Certificate of Appropriateness

Milwaukee Historic Preservation Commission/200 E. Wells Street/Milwaukee, WI 53202/phone 414-286-5712/fax 414-286-3004

Property 2807 W. STATE ST. Concordia Historic District
Description of work Rebuild front and east porches. Install new guardrail in attic balcony. Replace water table where missing. Spot replace clapboard siding with mitered corners where missing on all elevations. Rebuild brick chimney from roofline up. Install new roof shingles and built-in gutters.
Date issued 8/12/2013 PTS ID 87978 COA, exterior restoration

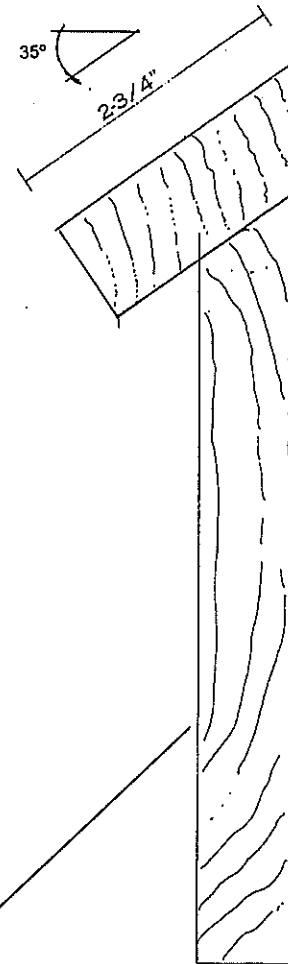
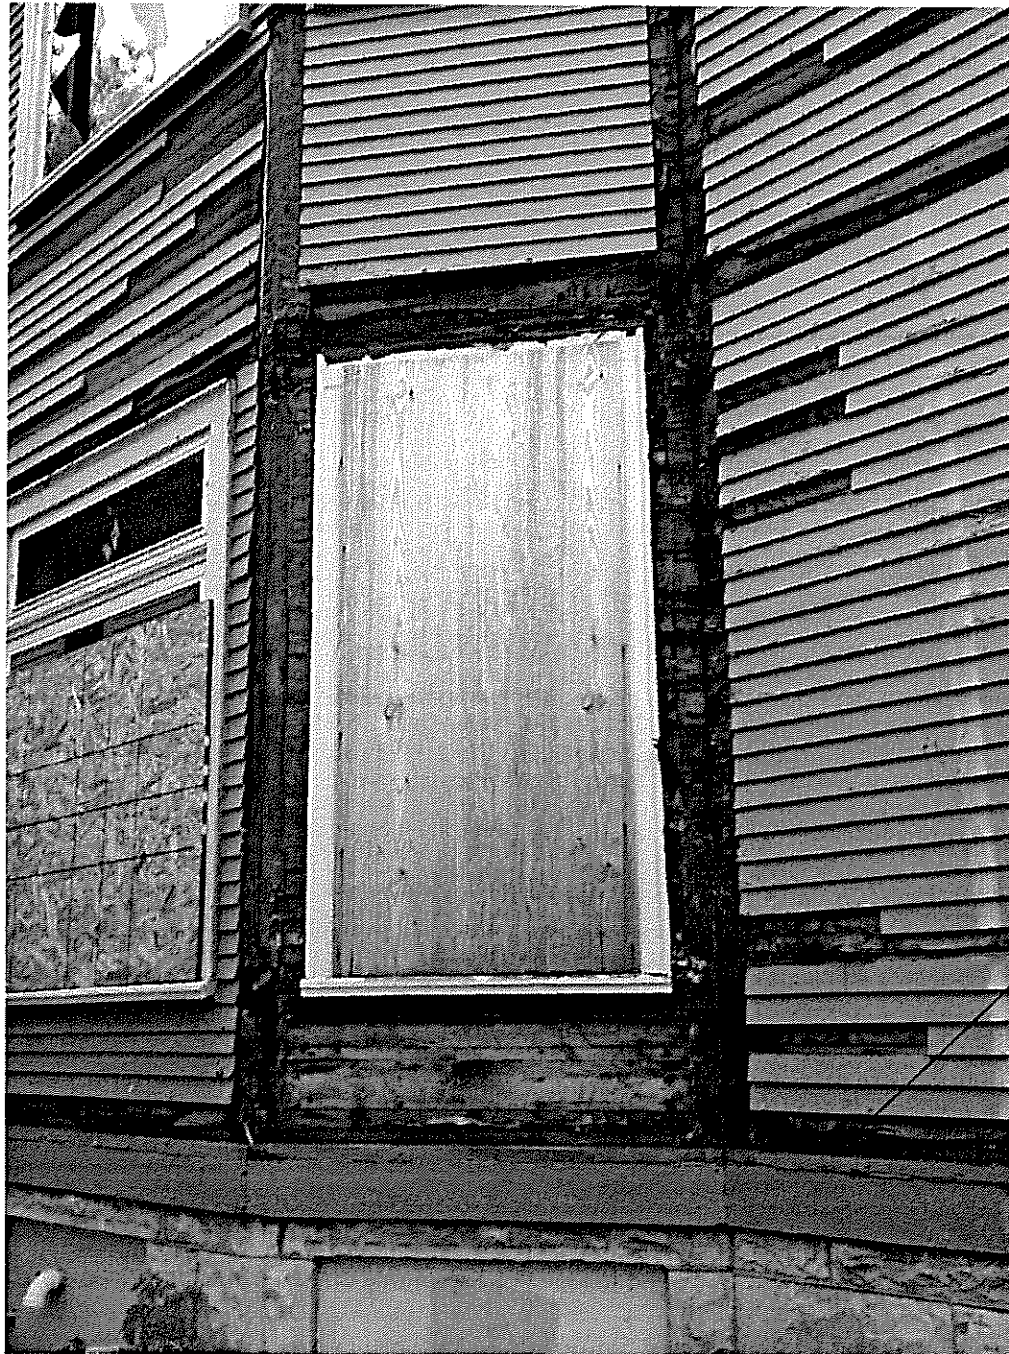
**Section and elevation
for attic guard rail to
be constructed on
front elevation of
house.**

**New balustrade
to be installed in
attic balcony per
the attached
drawings.**

**New front porch to be installed
here according to attached
drawings and specifications.**

WATER TABLE
AT TOP OF FOUNDATION

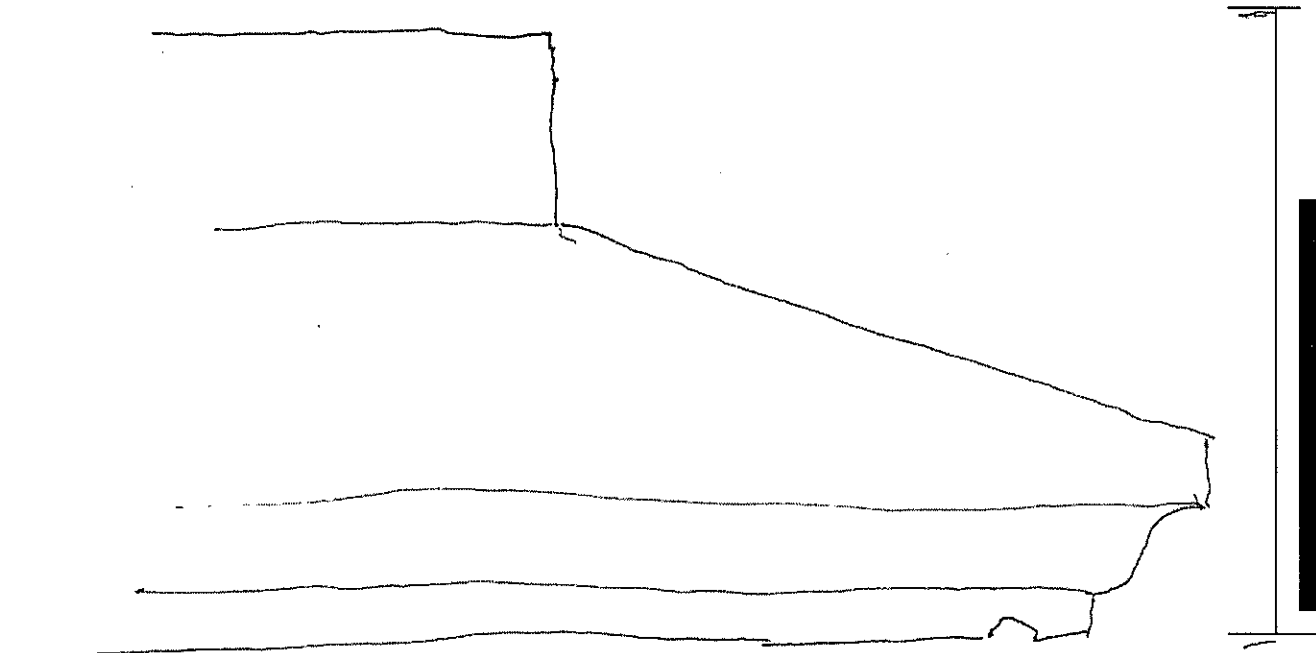
**Water table to be
installed around
perimeter of
building
according to this
section drawing.**

4 BUILT-IN GUTTER DETAIL
1 1/2" = 1'-0"

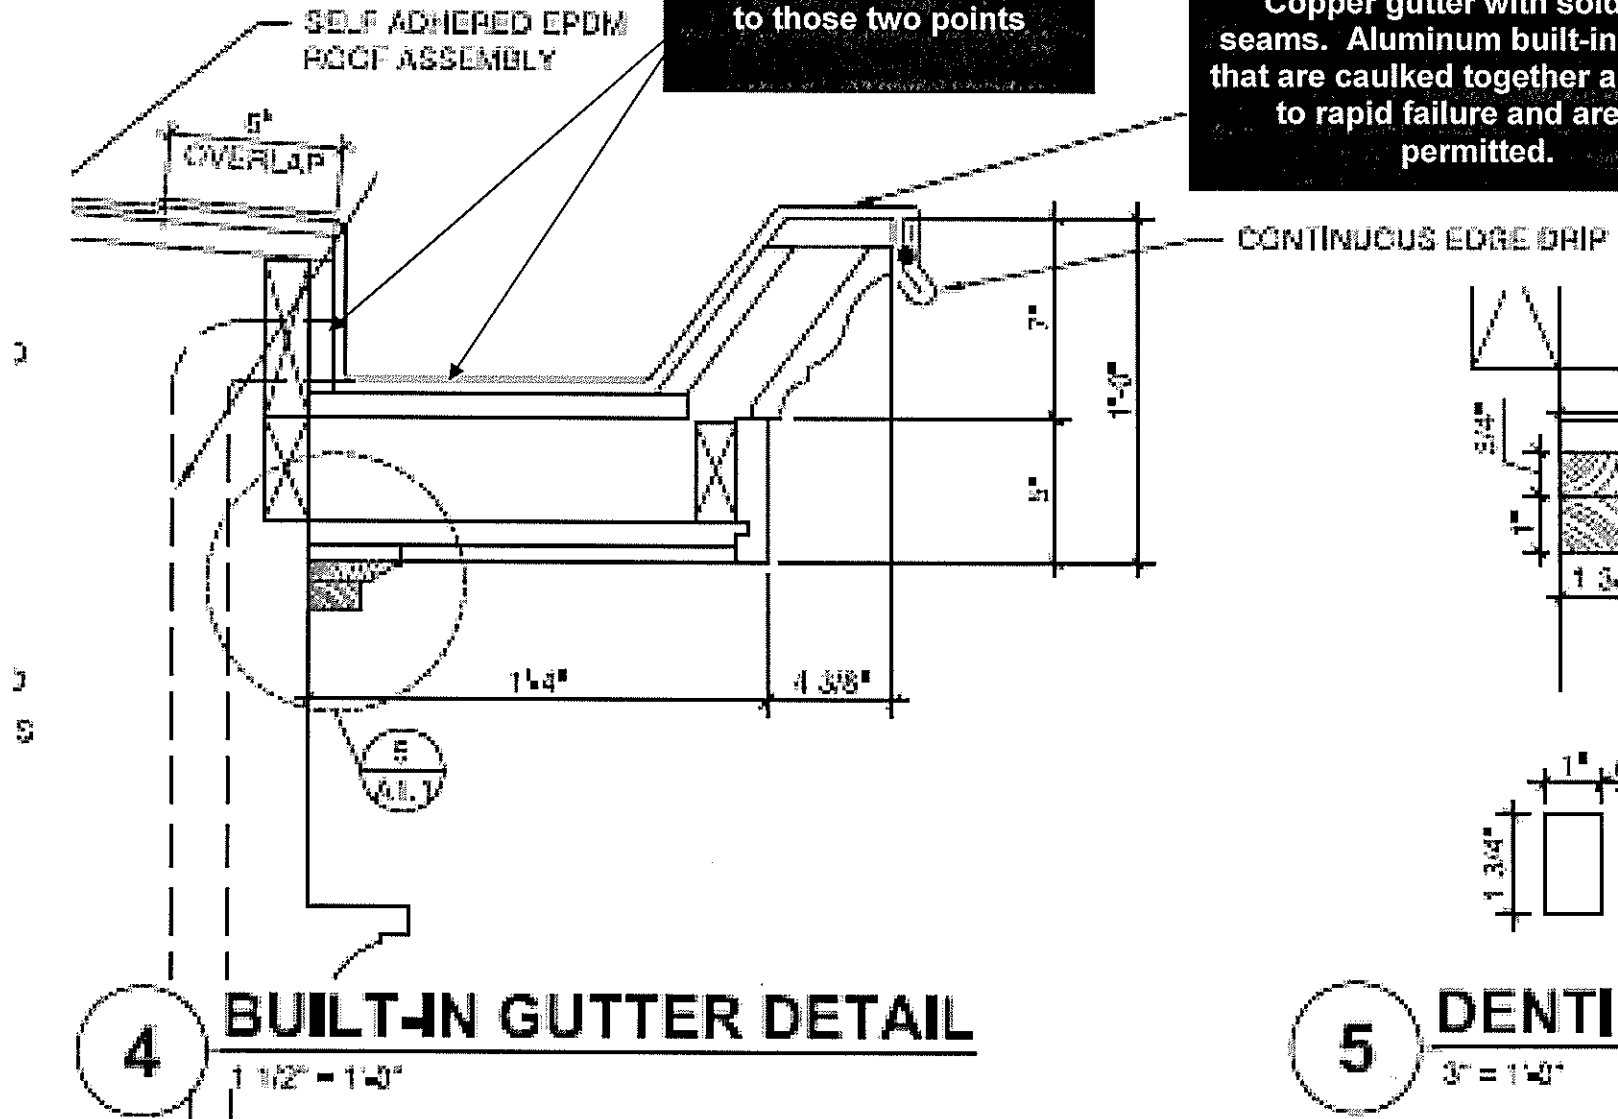
Drain must be in bottom of trough only, one at each end where the gutters meet the house. Gutters must be pitched to those two points

Copper gutter with soldered seams. Aluminum built-in gutters that are caulked together are prone to rapid failure and are not permitted.

POST AND FOOTING DETAIL
FOR OUTSIDE CORNERS OF
PORCH DECK
FULL SIZE

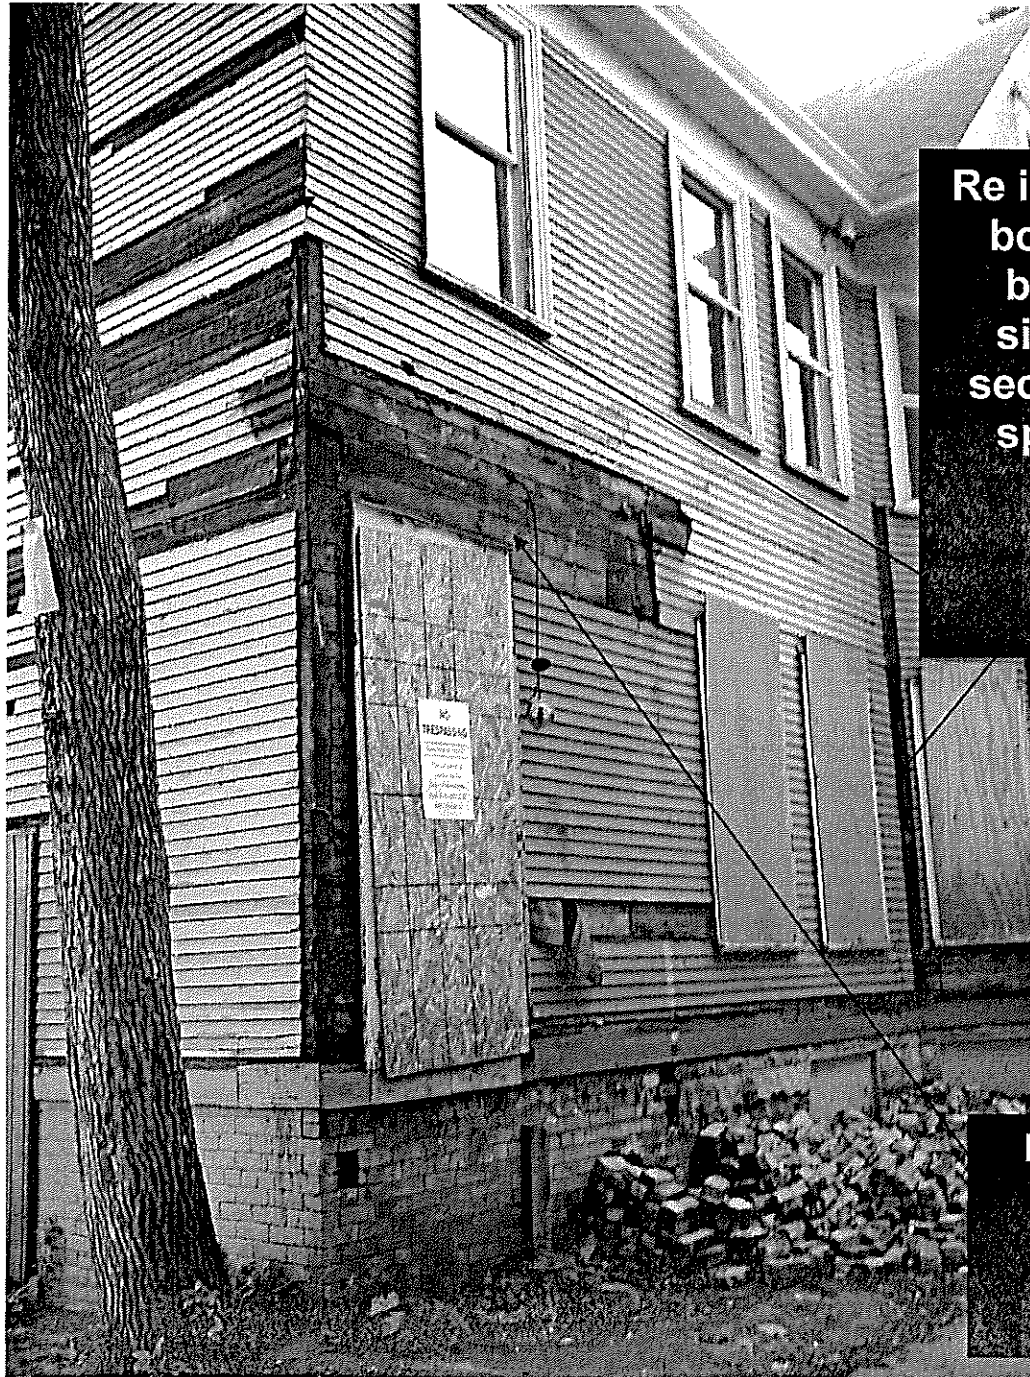
Concrete footing 8"
round in diameter and
four feet deep. Use
Sonotubes for form.

Section of footings for
outside corners of front and
side porches

*SIDE PORCH 2807 W. STATE
REAR PORCH 2808 W. WELLS (EAST ELEVATION)
SCALE: 1" = 1'-0"*

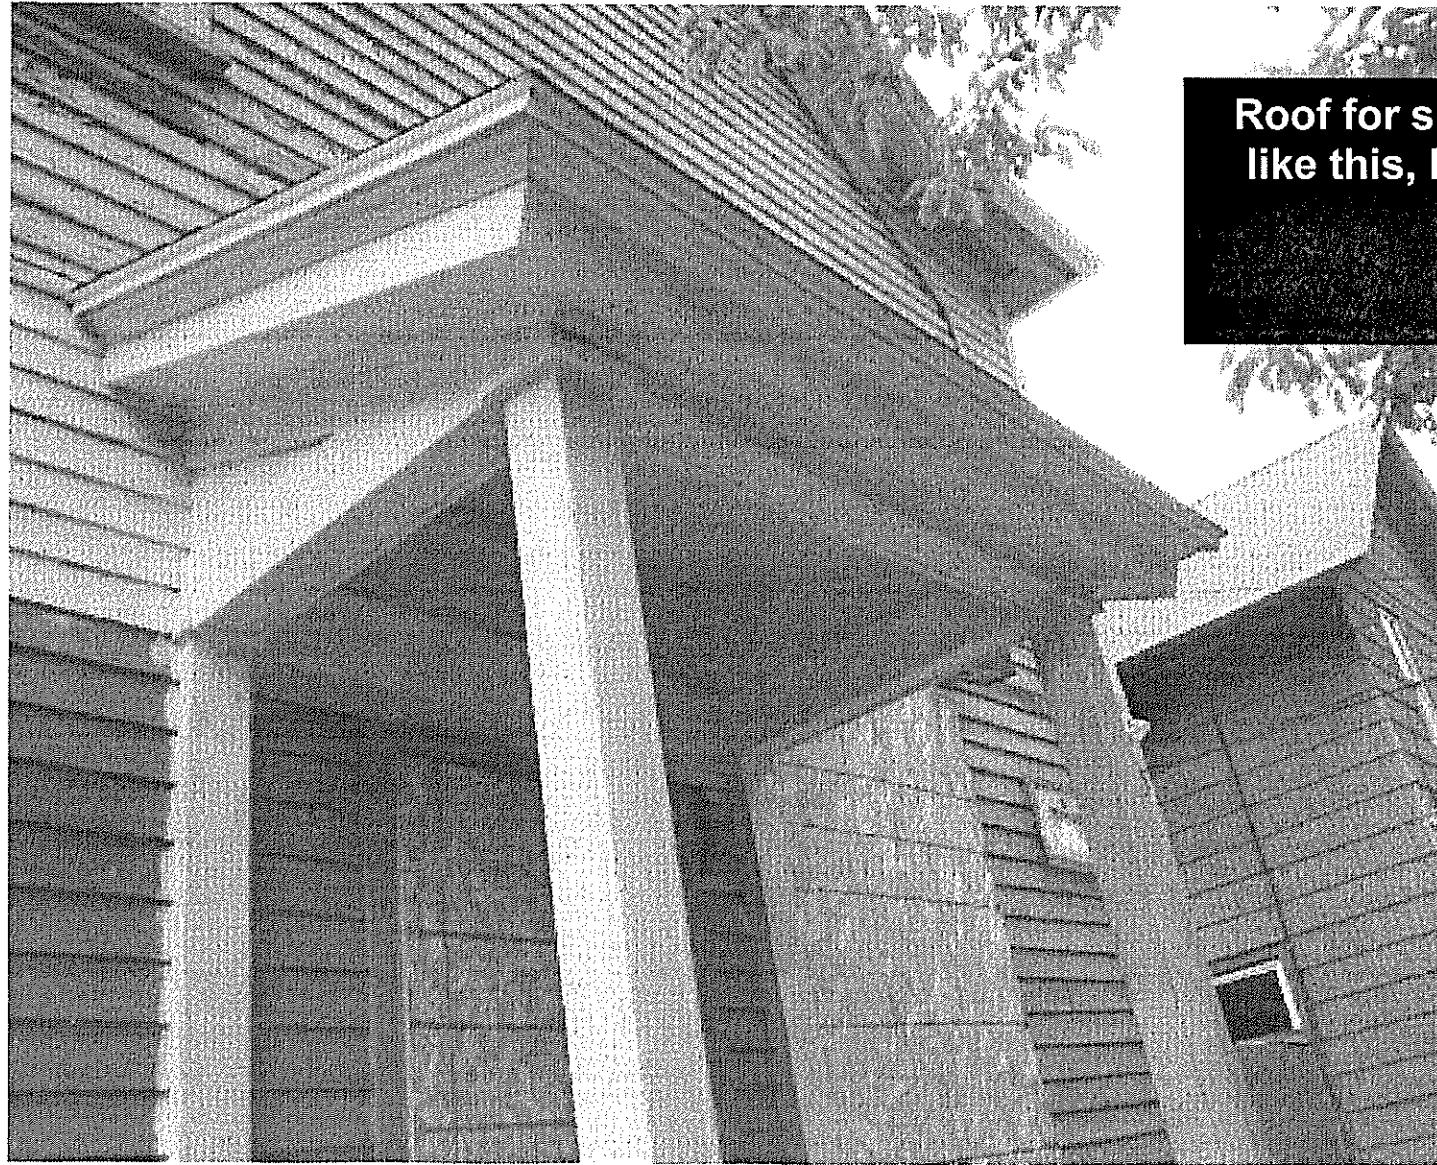
**Infill panel
with v-joint
1/4 material**

**The steps must be
located on the east
elevation of the porch,
not the south as drawn
here.**

**Newel post #08 from
Cinderwhit.com 6 inches
square ACTUAL**

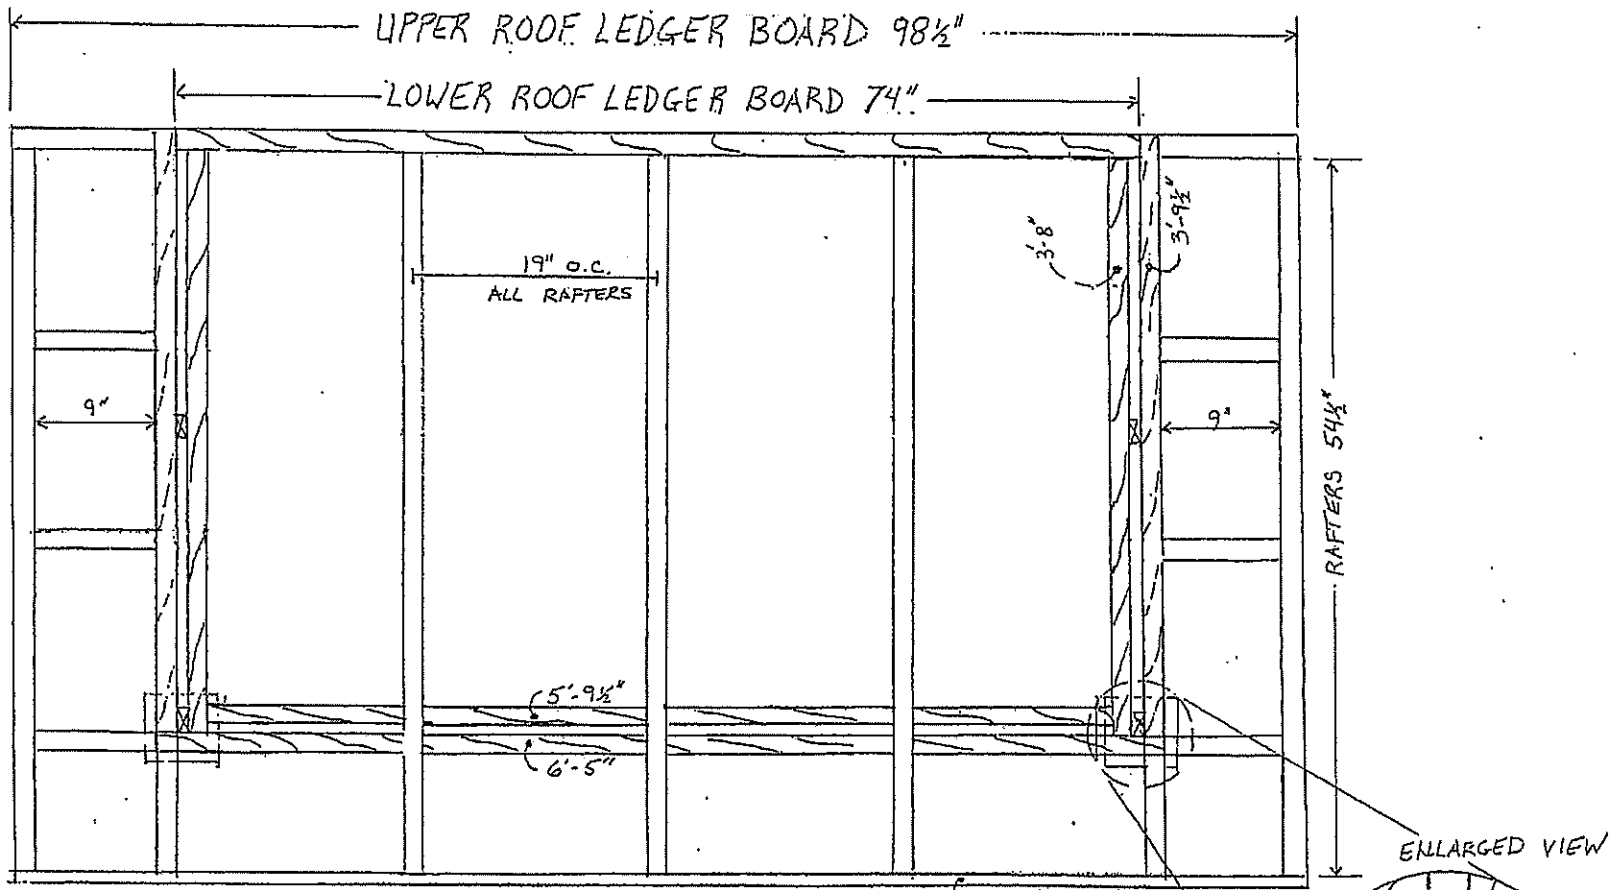
Roof for side porch will look like this, but at a 10/12 roof pitch
